## Service Bulletin

NO: PV2-02-006

**SUBJECT:** LS Guide Roller A, Parts Addition

**MODEL (S):** MDX-M2000

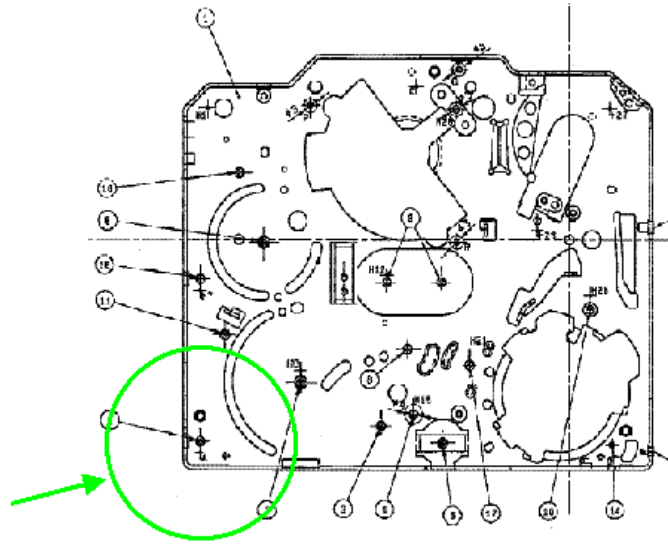
**SYMPTOM:** When loading, it gets excessive stress.

**SOLUTION:** To add LS guide roller A mech chassis assy. Please order the Additional combination parts listed below:

Current combination	Additional combination
MECH CHASSIS Assy X-3951-300-1	MECH CHASSIS Assy X-3951-300-2
M1.4 SCREW 3-947-503-01	<b>LS GUIDE ROLLER, A</b> 3-074-309-01
	<b>1.2E RING</b> 7-624-101-04
